NEW STYLE ONE-PIECE FILTER MAGIC II FILTER PAN

This new one-piece pan replaces both inner and outer pan assemblies.

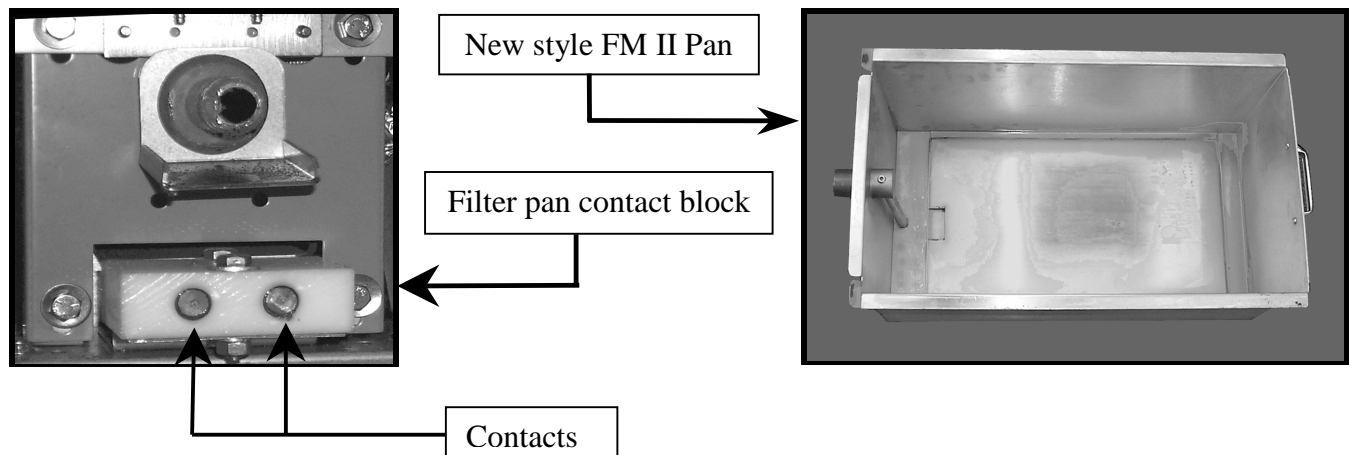
When this pan is used in older FM II Frymaster fryers in place of the previous two-piece Filter Magic II pan assembly:

1. Be certain that the heater contacts in the white nylon contact block below the filter pump slip fitting are recessed (inset about 1/8"-1/4"). If contacts are NOT recessed, unplug fryer from the wall. Either remove or cut the wires going to the block and insulate the ends, or remove the entire block and insulate the wire ends.
2. The green "FILTER READY" light will not illuminate. This is normal.

- ◆ **This pan is designed to be used with filter paper or 19" x 10" aftermarket pads only.** Due to the built-in pump connector on this pan, it may not be possible to use some aftermarket filter screen or pad systems.
- ◆ A pan heater is no longer used. In this new pan, the suction tube runs inside the pan and is heated by the hot drained shortening.
- ◆ The old style inner filter pan is not used with the new pan.
- ◆ The filter paper hold-down ring and crumb screen are the same as the previous style.
- ◆ If your present flat filter support screen will fit, use it. If it is the "Sana-Grid" aluminum mesh and is too long for the new pan, you may cut 5/8" off one end. If your screen is another style and won't fit into the recess in the new pan, contact your local service company to order a replacement screen. The part number for the correct screen is 810-1229.
